# **Boston Harbor, Massachusetts, Deep-Draft Navigation Improvement Project Feasibility Study**

Channel Improvement Investigations

Final report

Boston Harbor Channel Improvements  
Final Questionnaire

Figure 14. Recommended modifications to the Plan 1 turning notch.

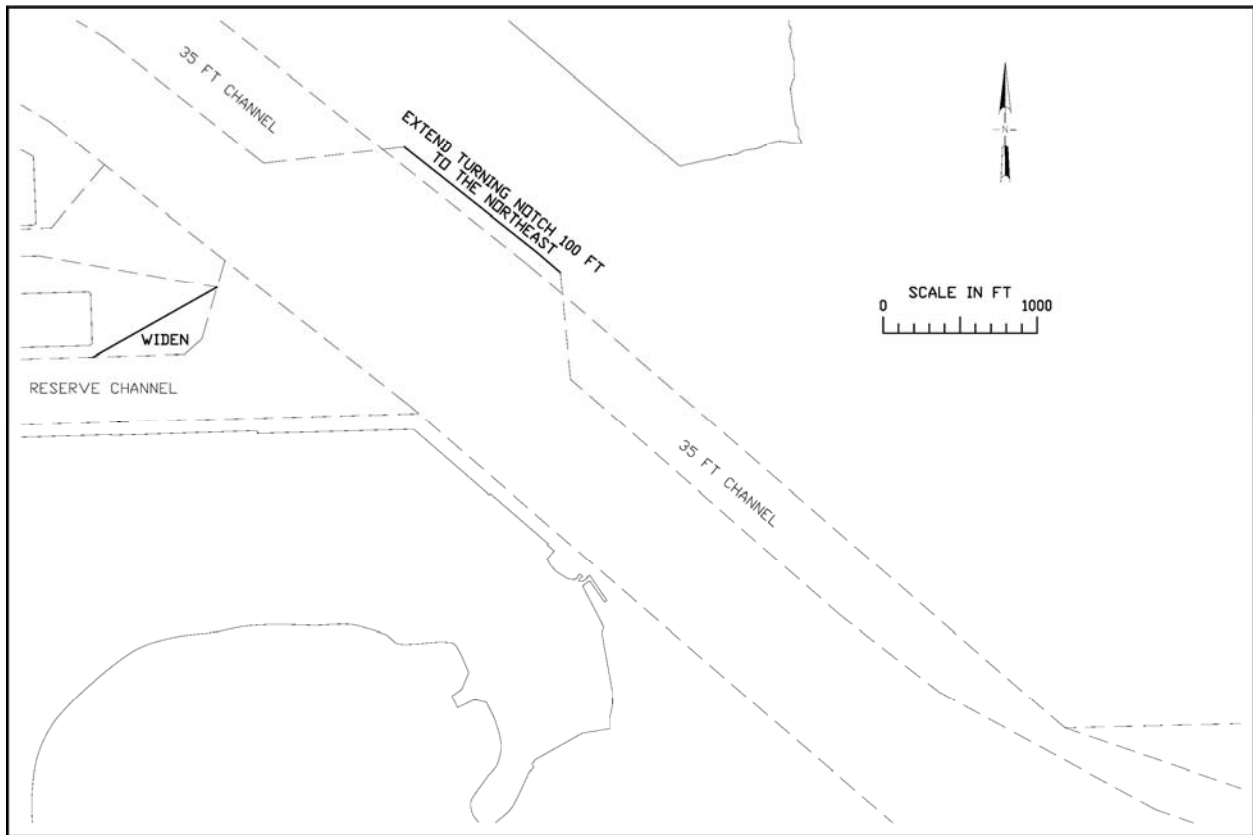
- c.* The Plan 1 turning notch is recommended with the modifications shown in Figure 14. A number of ships left the northeastern edge of the turning notch. This edge should be extended 100 ft. A number of ships also left the northeast end of the Reserved Channel. Modifying the Plan 1 notch to resemble the Plan 2 notch in this area is recommended.

Figure 1. Boston North Channel Bend Widener

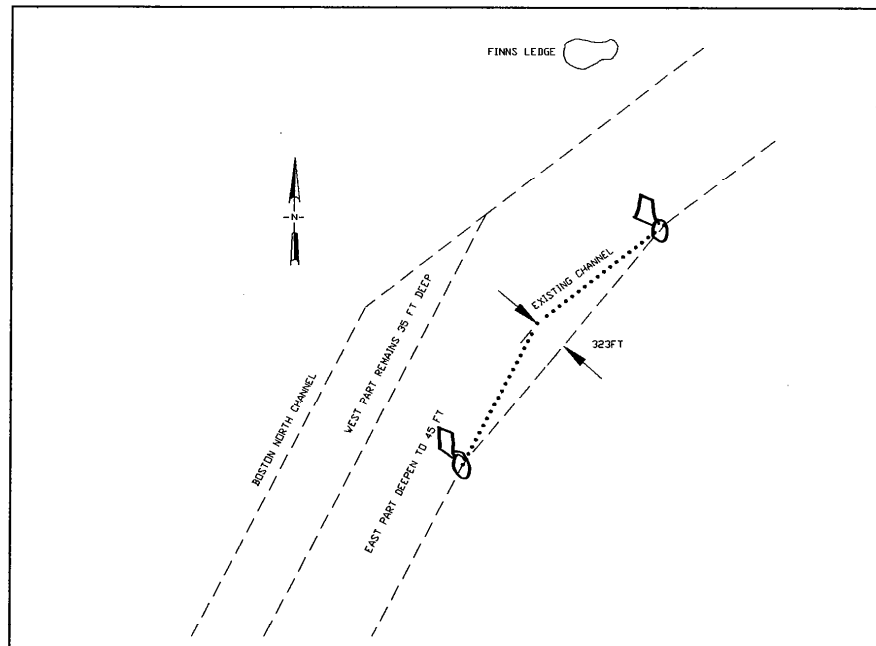
d. Should the widener be modified? Feel free to sketch on Figure 1.

Configuration is good. I believe buoys are planned for corners.

Figure 2. Spectacle Island Widening

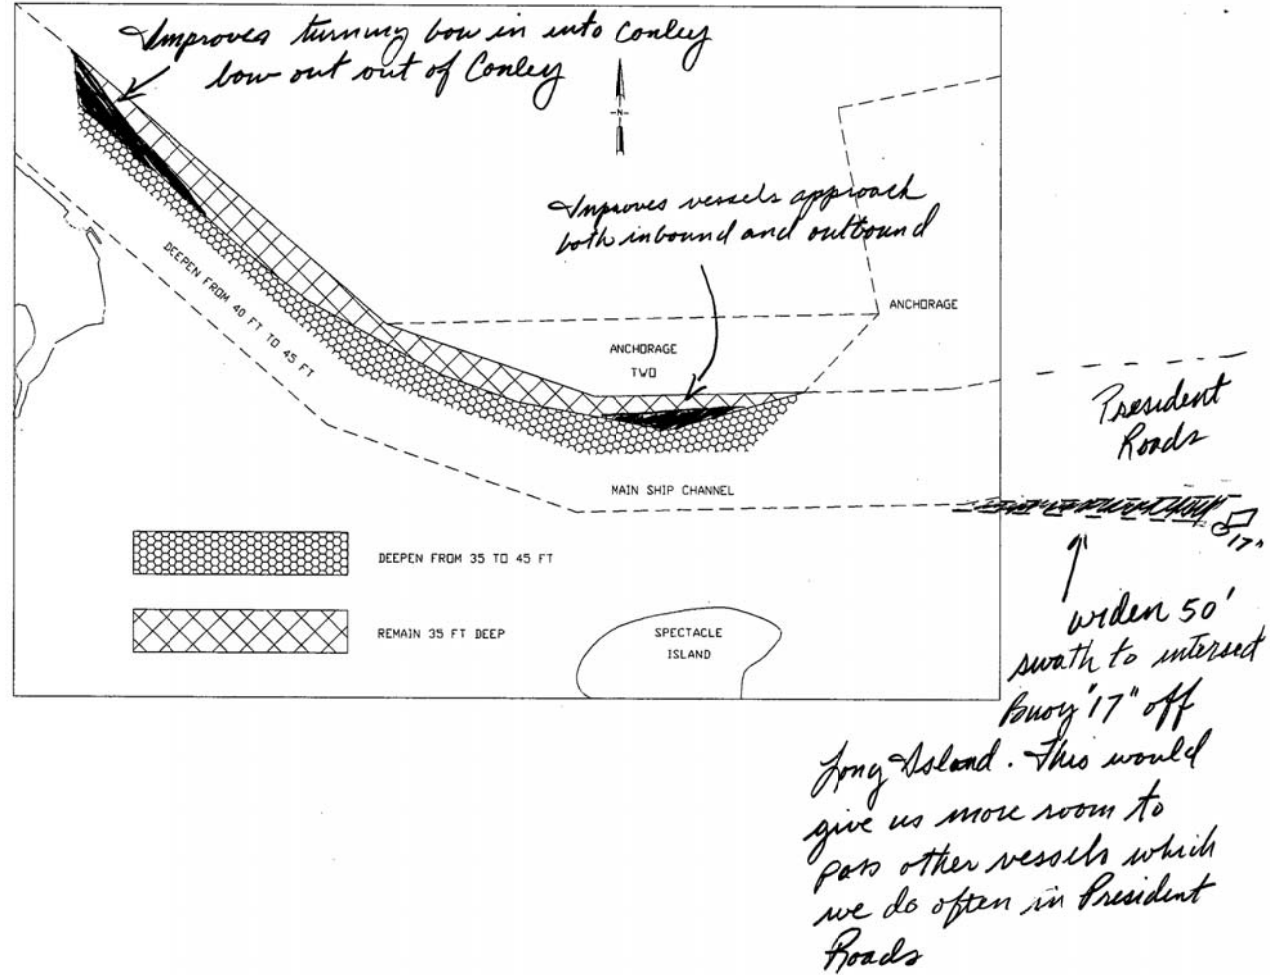
- d. Should the channel width in the straight sections or in the two turns be modified? Feel free to sketch on Figure 2.

*The proposed wider would be a great improvement. Additional improvements are noted on sketch.*

Figure 3. Widening near mouth of Reserve Channel

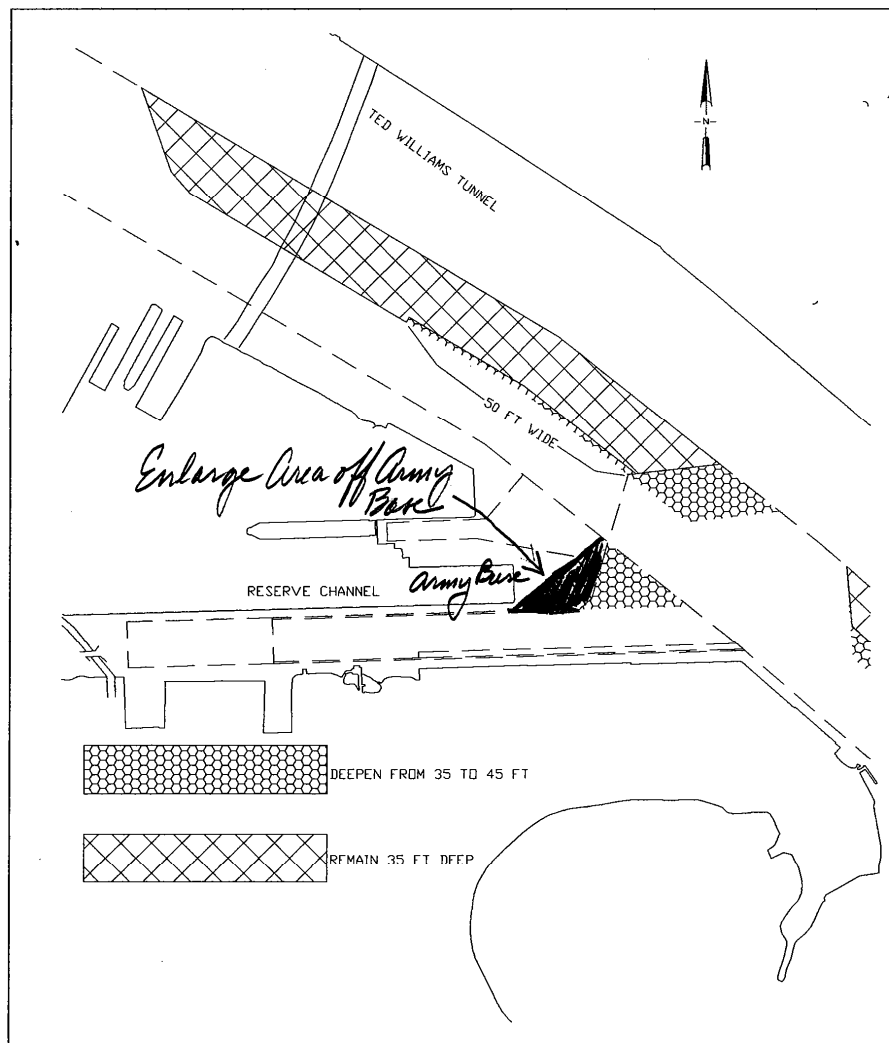
- a. Based upon your simulation runs, do you feel that the enlarged turning area provided adequate room for both the *COSCO Hamburg* and the *Delaware Bridge*?

*It can be done, but would benefit from larger area off Army Base*

- c. Should the enlarged turning area be modified? Feel free to sketch on Figure 3.

*Yes, see sketch*

Figure 1. Boston North Channel Bend Widener

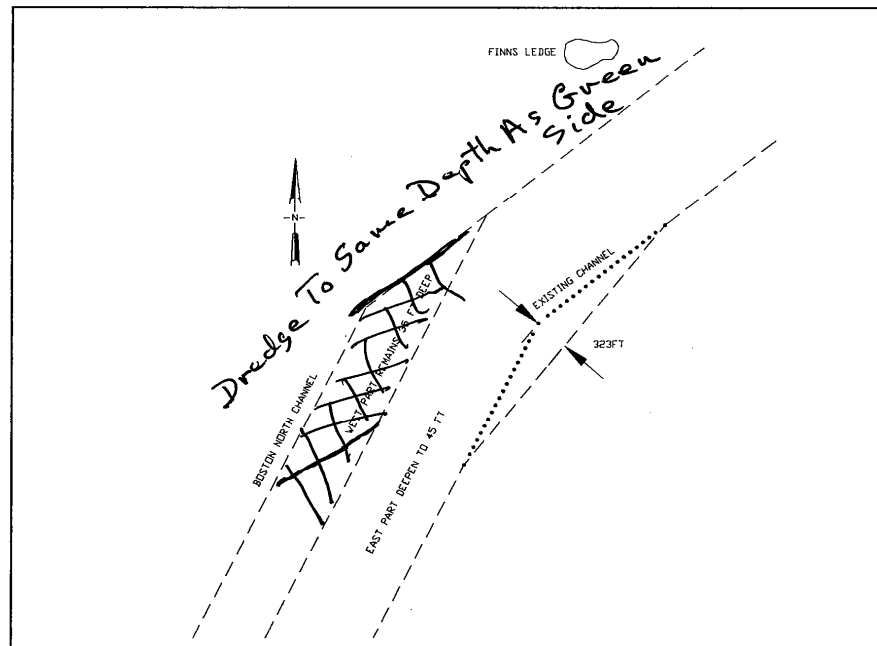
- d. Should the widener be modified? Feel free to sketch on Figure 1.

See sketch!

Figure 2. Spectacle Island Widening

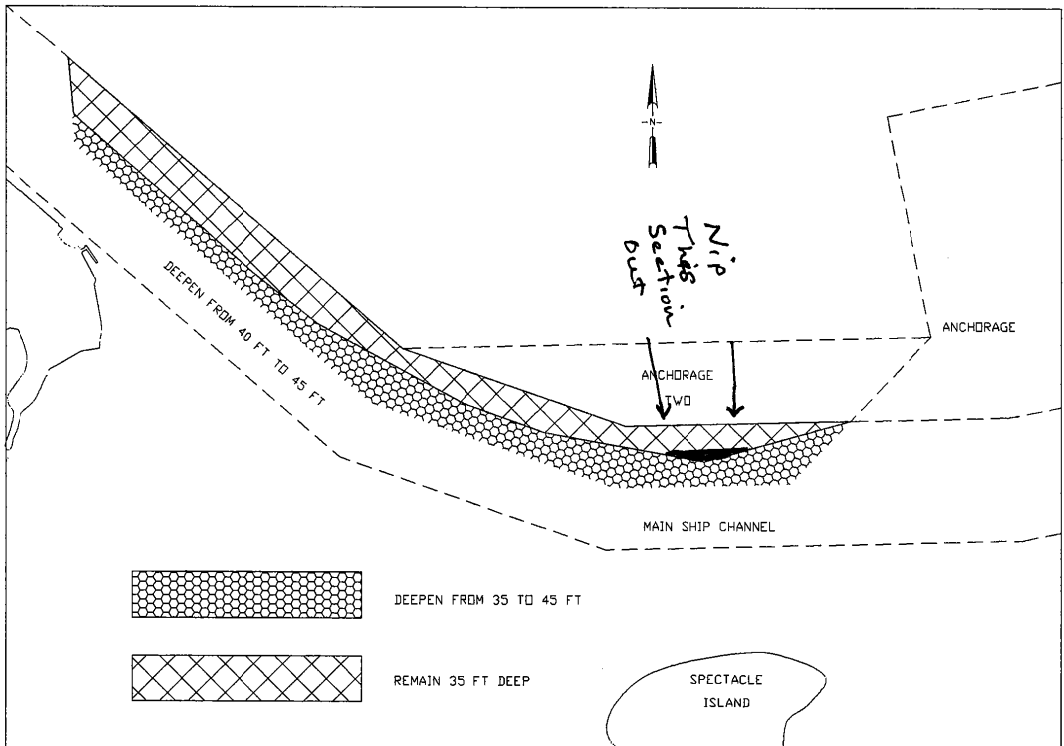
- d c. Should the channel width in the straight sections or in the two turns be modified? Feel free to sketch on Figure 2.

See Note on Sketch.

Figure 3. Widening near mouth of Reserve Channel

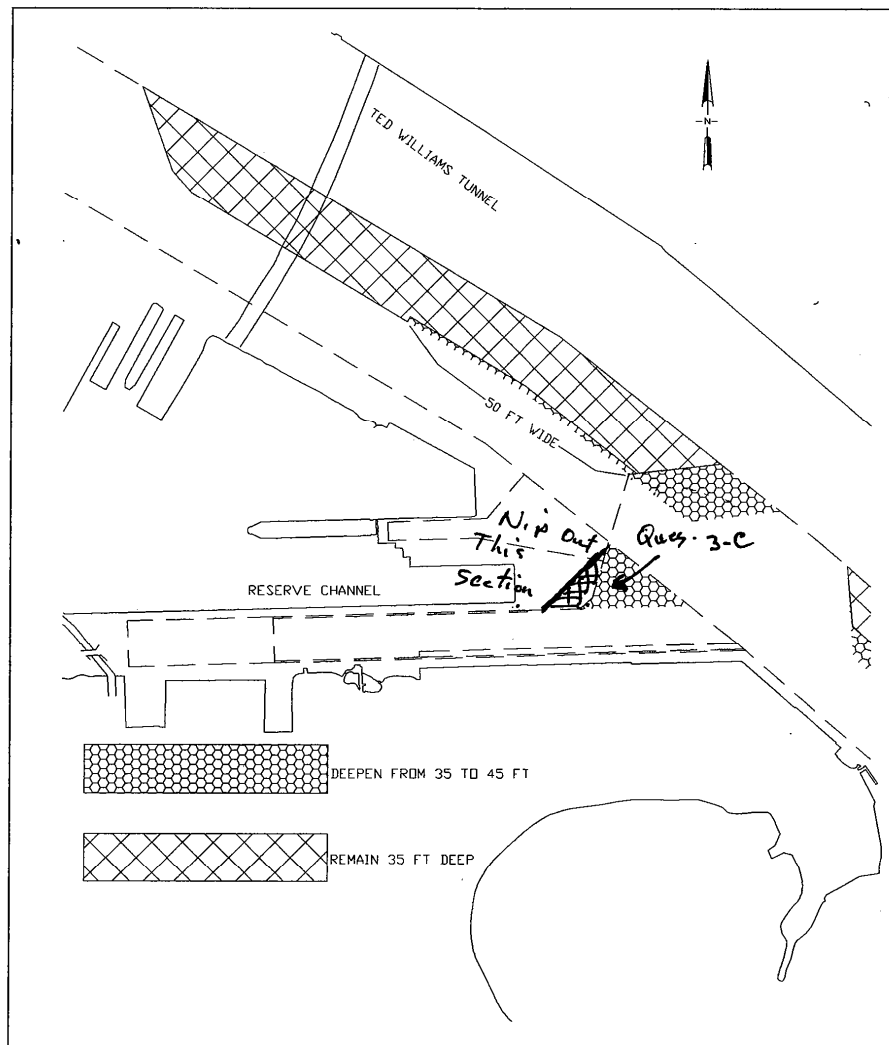
- c. Should the enlarged turning area be modified? Feel free to sketch on Figure 3.

Yes (See Note on Sketch.)

Figure 3. Widening near mouth of Reserve Channel

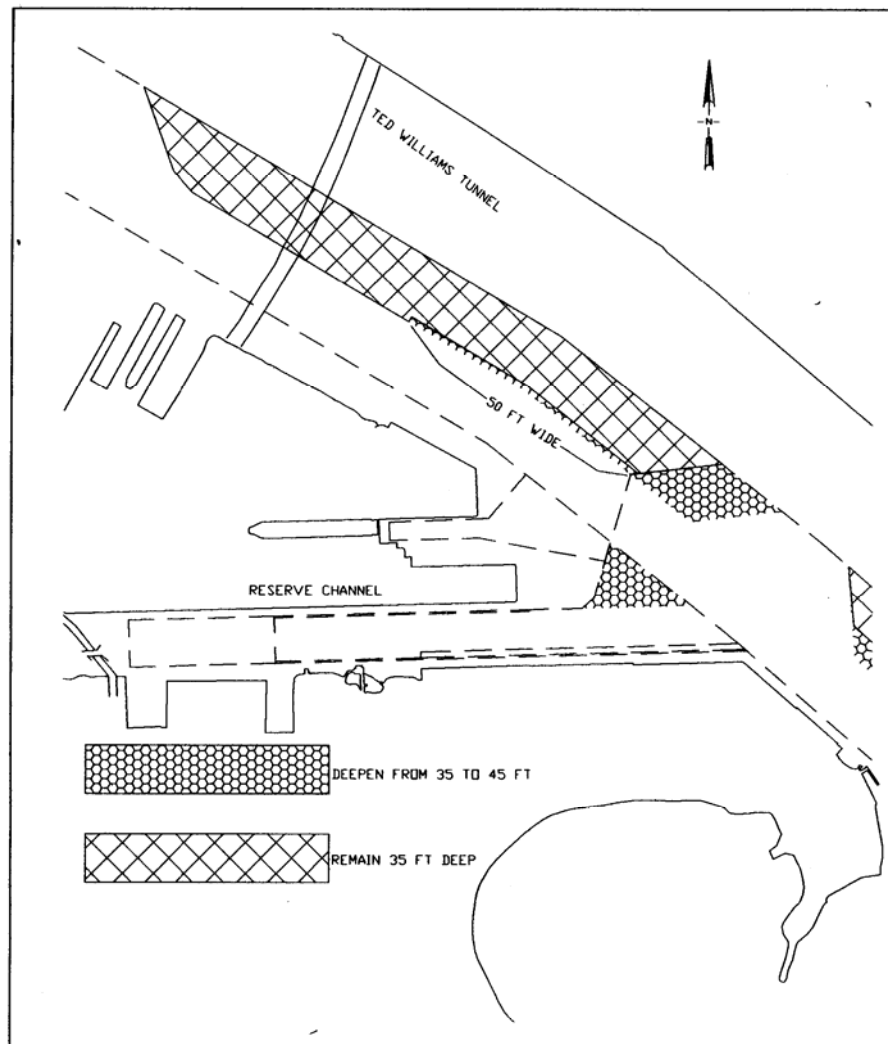
- c. Should the enlarged turning area be modified? Feel free to sketch on Figure 3.

YES. I PREFER THE ALTERNATIVE TURNING NOTCH AS SHOWN IN FIGURE 4. THIS PROVIDED FOR AN EASIER TURN AROUND BOTH INBOUND AND OUTBOUND. IT ALSO KEEPS THE SHIPS AWAY FROM THE AIRPORT RUNWAY.

Figure 4. Plan 2 turning notch

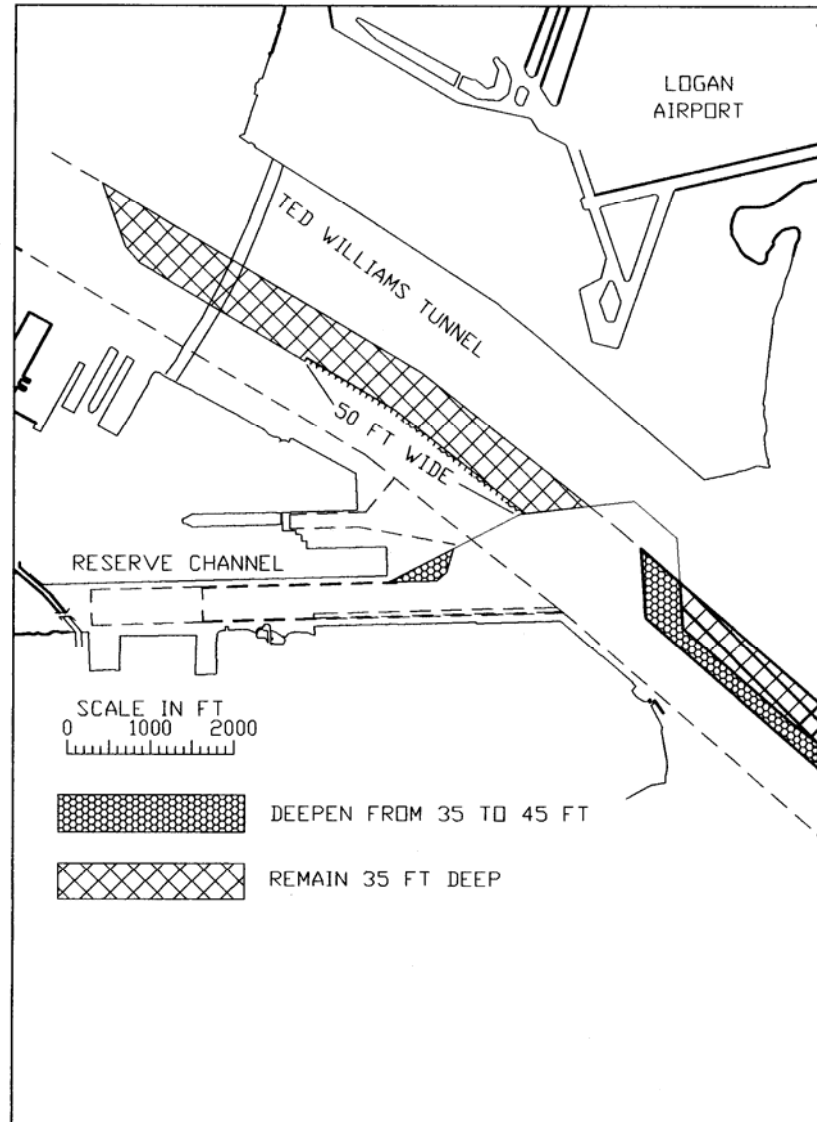
- c. Should the enlarged turning area be modified? Feel free to sketch on Figure 4.

NO. I PREFER THIS TURNING AREA  
OVER THE OTHER PROPOSAL. IT MAKES  
FOR MUCH EASIER TURNS.

Figure 3. Widening near mouth of Reserve Channel

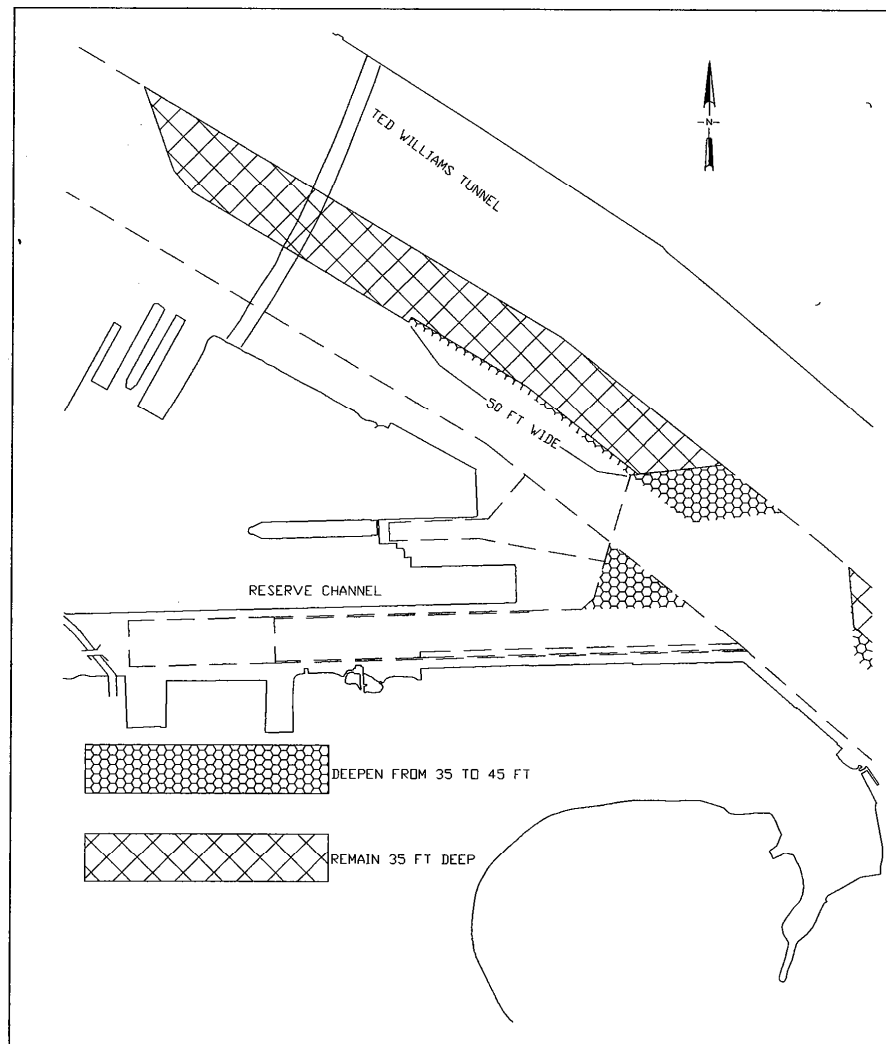
- c. Should the enlarged turning area be modified? Feel free to sketch on Figure 3.

SEE PROPOSAL <sup>1</sup> 2

Figure 4. Plan 2 turning notch

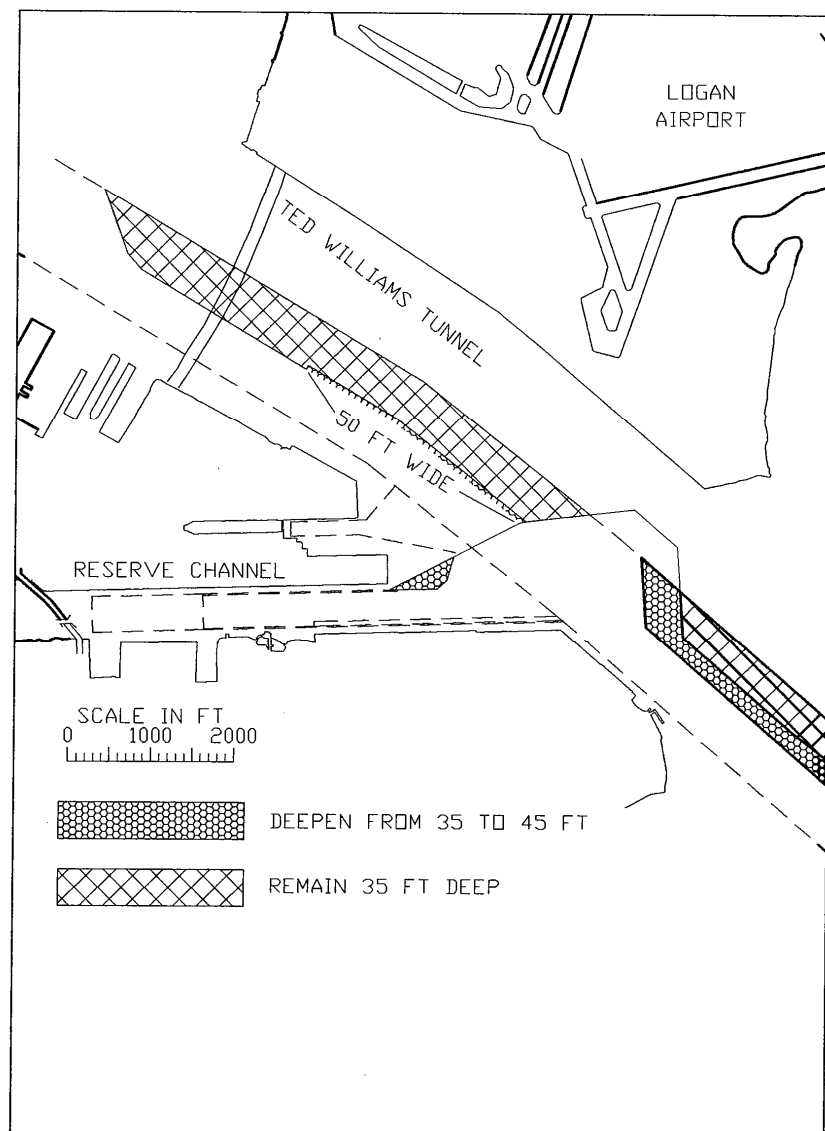
IF INTENT IS TO MINIMIZE IMPACT TO AIR TRAFFIC,  
THE ALTERNATIVE NOTCH WORKED WELL.
